ISSUE: Certificate of Appropriateness for new construction

APPLICANT: City of Alexandria and Washington Metropolitan Area Transit Authority (WMATA)

LOCATION: Old and Historic Alexandria District
2500 Potomac Greens Drive (2405, 2501, 3701 Potomac Avenue, 3251 Potomac Avenue [Parcel ID 016.04-01-01], 700 Carpenter Road, 1702 and 1880 Potomac Greens Drive) 2901 Potomac Avenue (2405, 2501, 3701 Potomac Avenue, 3251 Potomac Avenue [Parcel ID 016.04-01-01], 700 Carpenter Road, 1702 and 1880 Potomac Greens Drive)

Potomac Yard Metrorail Station

18. Provide Additional Information on the Entrance Pavilion

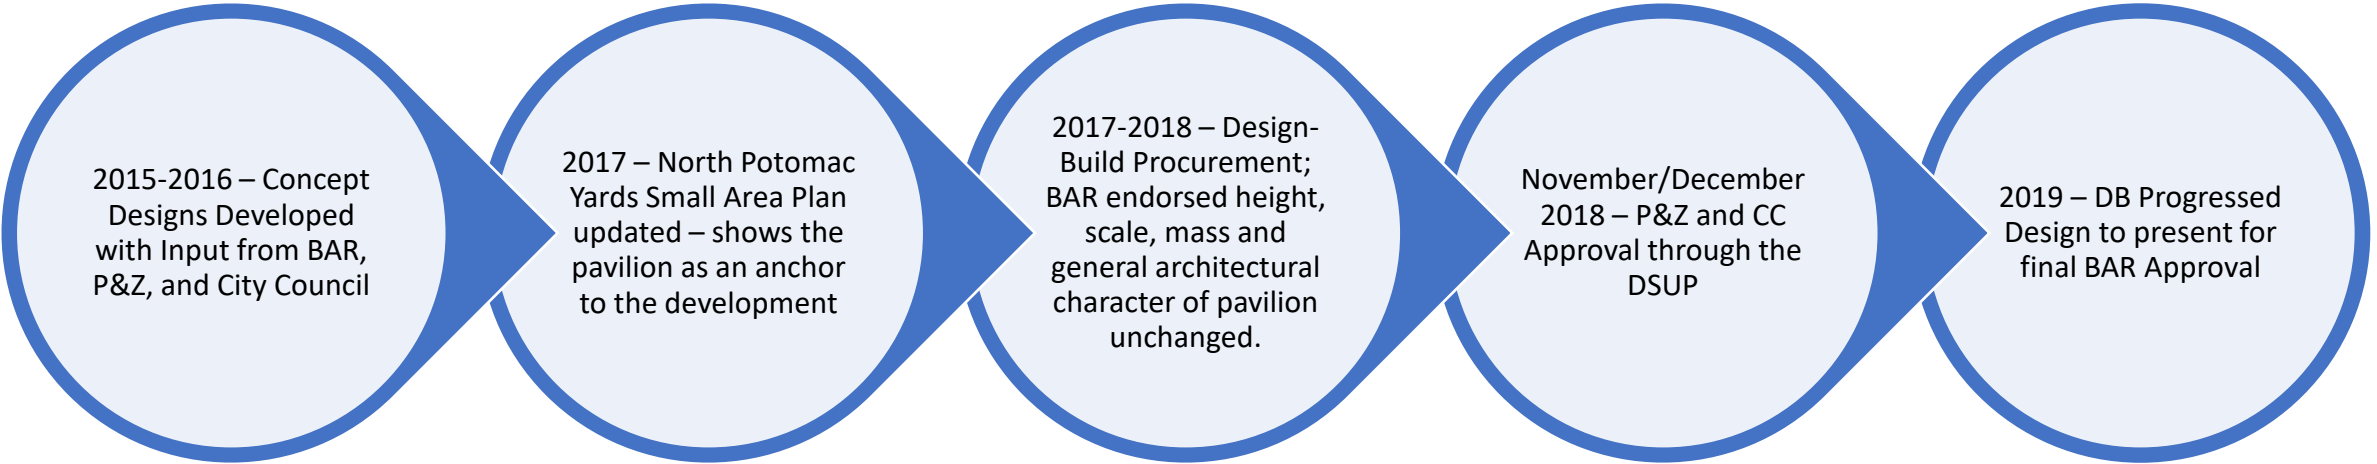
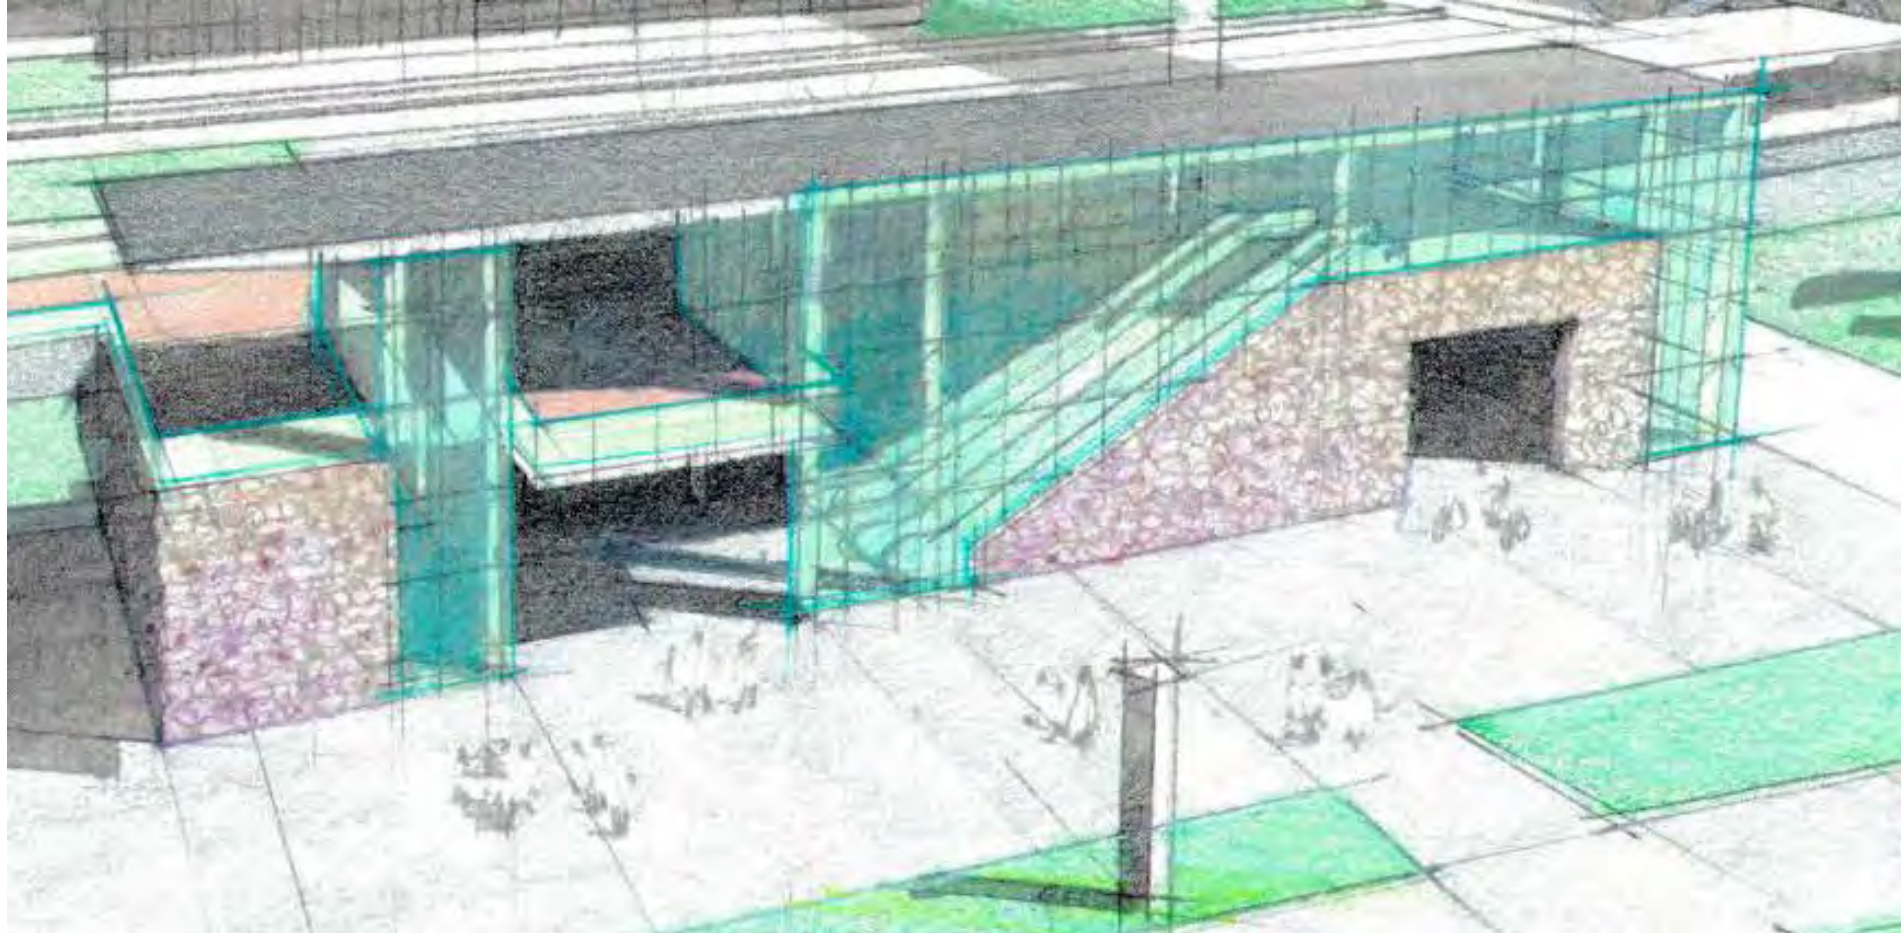
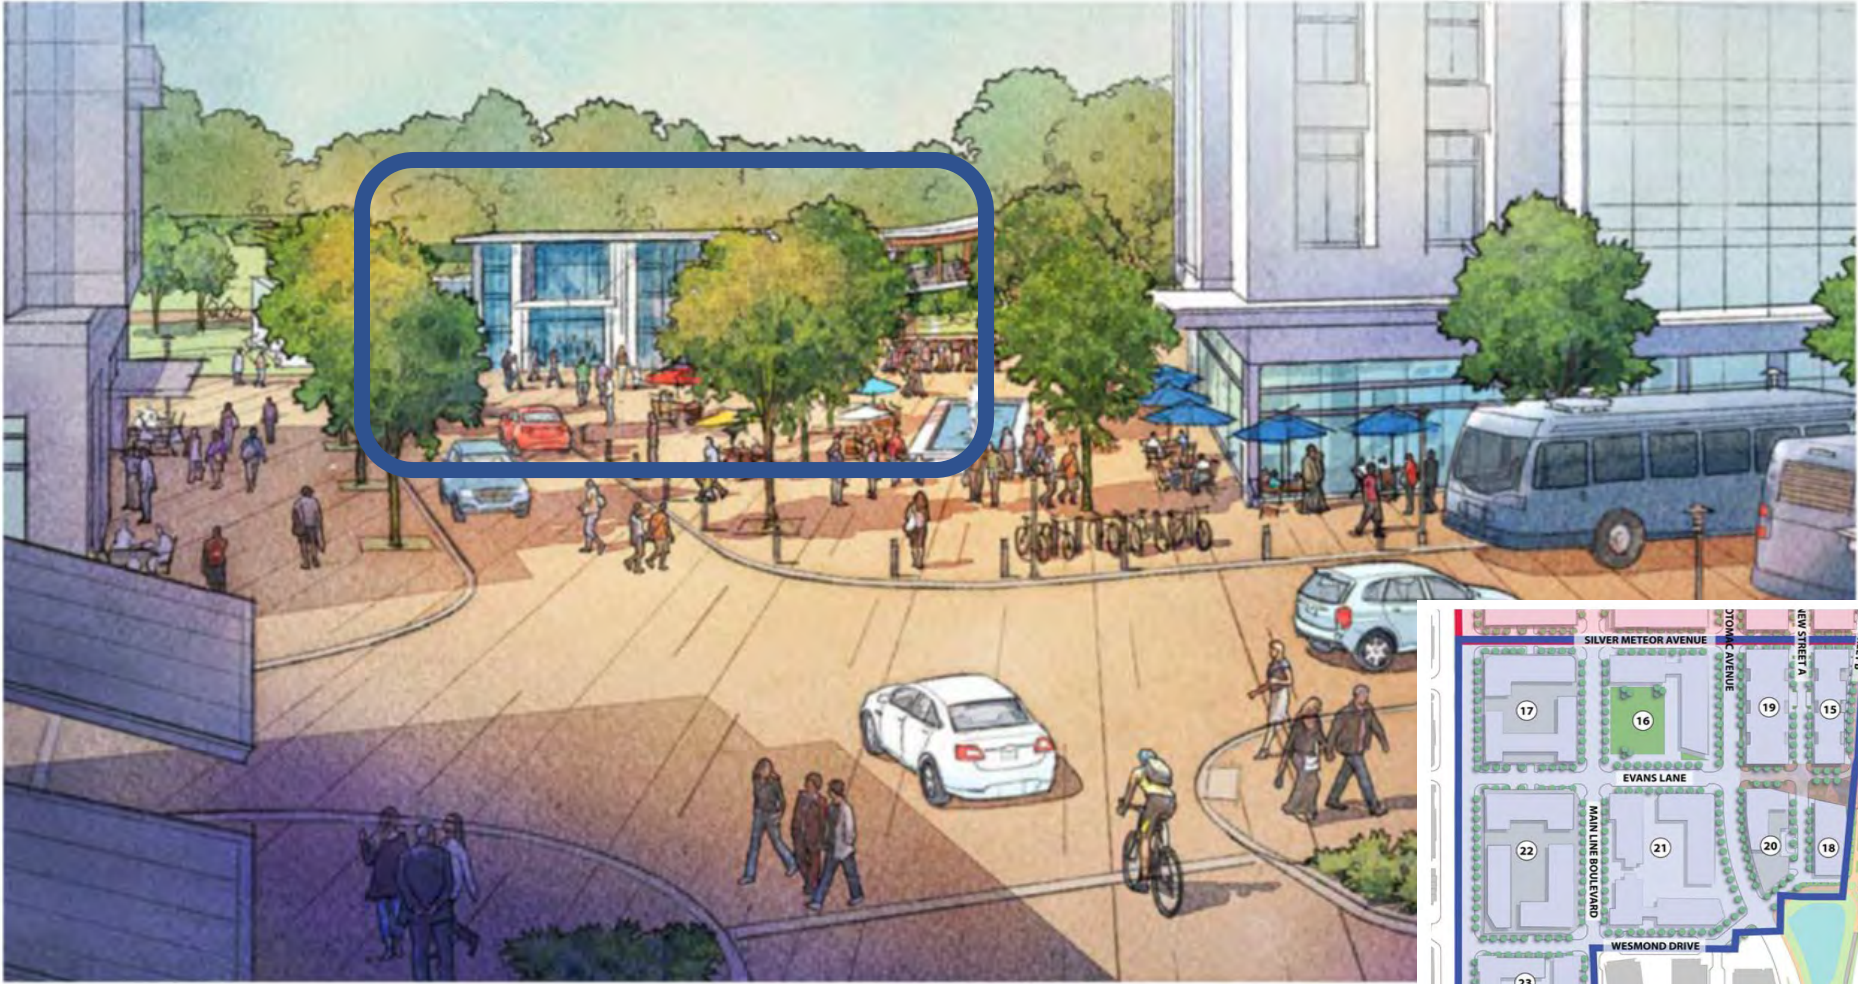
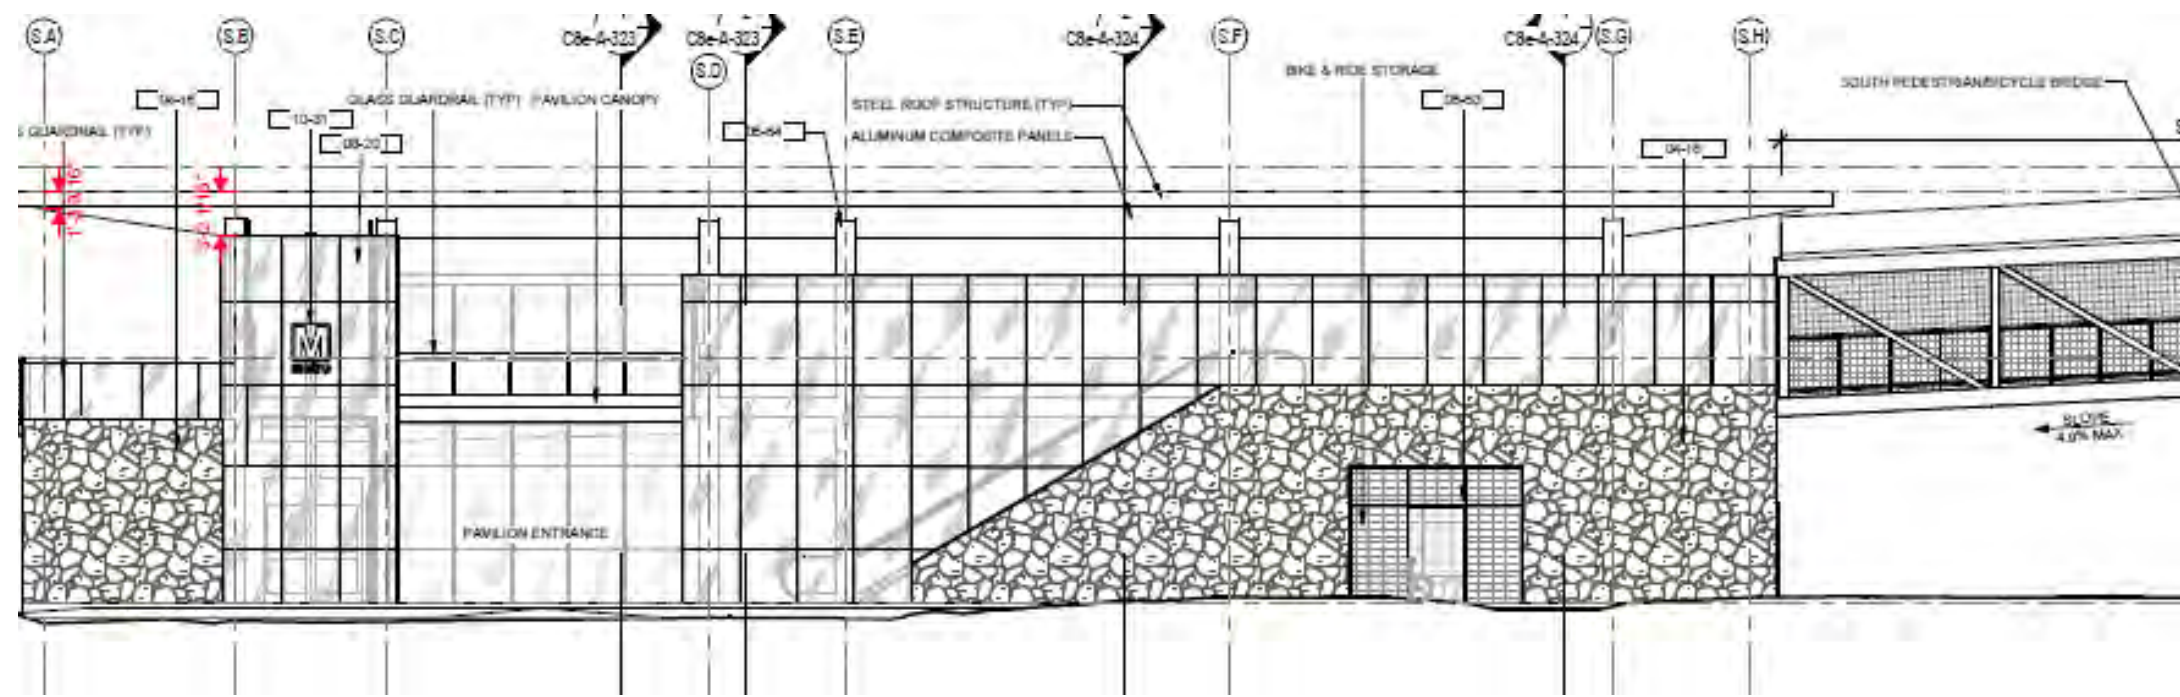
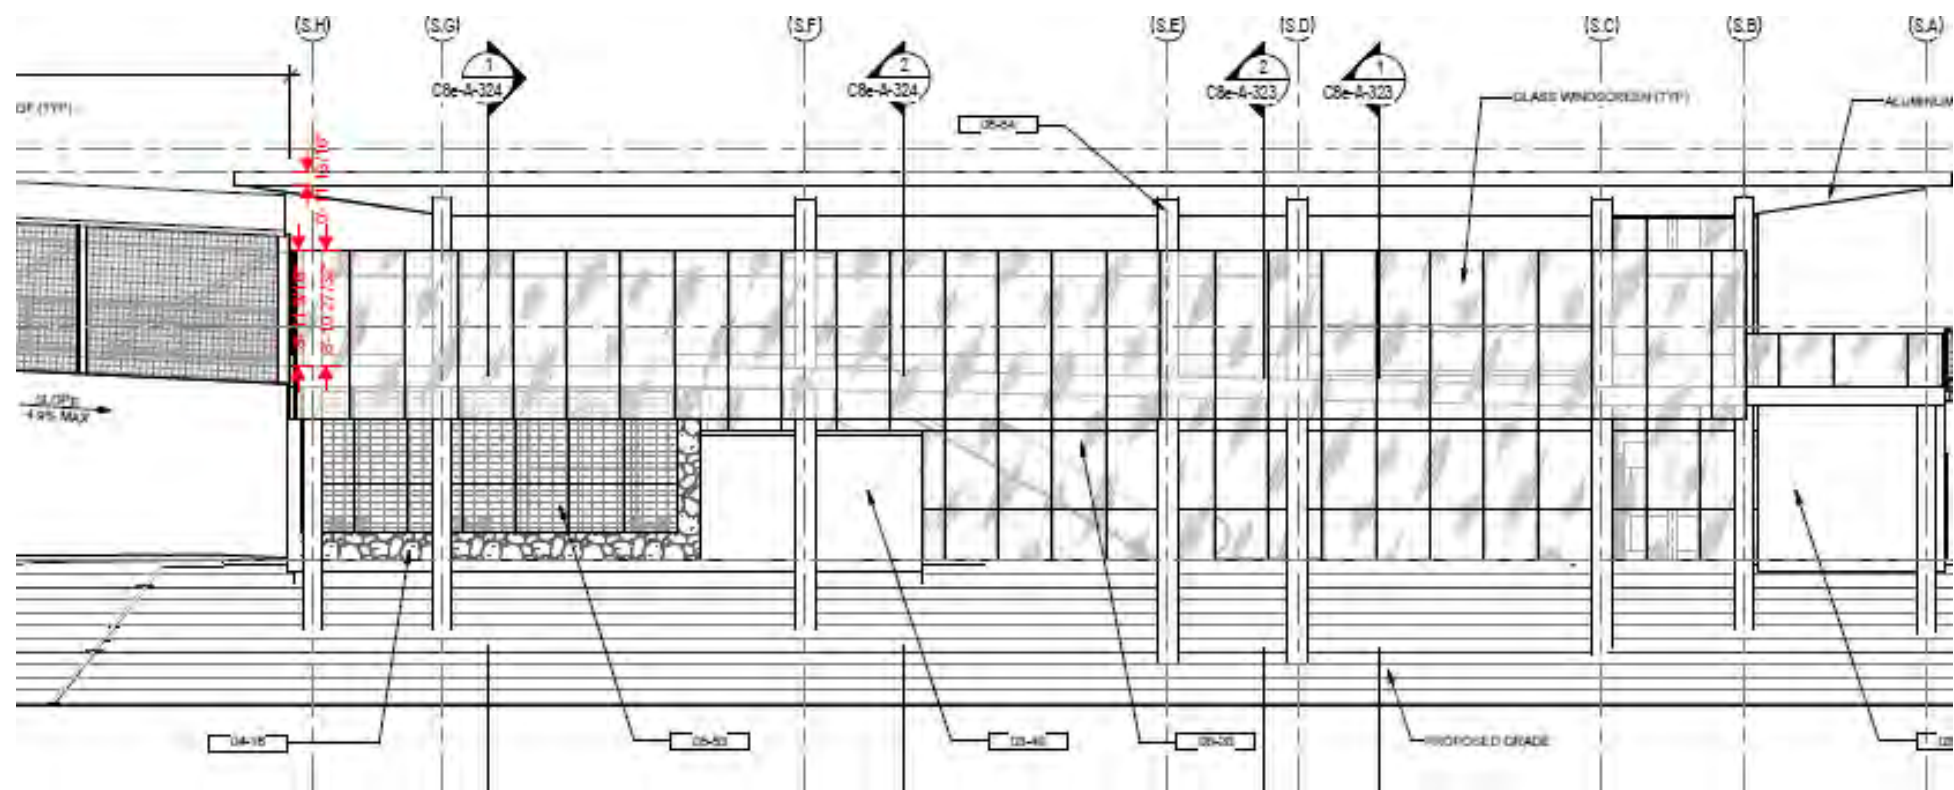
However, the architectural details of the pavilion have not been advanced from the concept review. For instance, no lintels are shown over the openings in the fieldstone walls. While longer pieces of cut stone may have visual structural support, fieldstone does not. Staff suggests that either lintels be expressed or the stone for the entrance be the same stone as the station but in a random ashlar pattern. In addition, there is no coping shown at the top of the stone walls. It is also not clear from the soft colored renderings what the mullion and support system is for the glass walls. These fundamental architectural details on the exterior of a structure are a normal part of the BAR's review.

Item	Status
17.	Restudy platform mesh to a style with a heavier horizontal wire or extend the glass curtain wall	Open – to be presented at tonight’s meeting
18.	Provide Additional Information on the Entrance Pavilion	Open – to be presented at tonight’s meeting
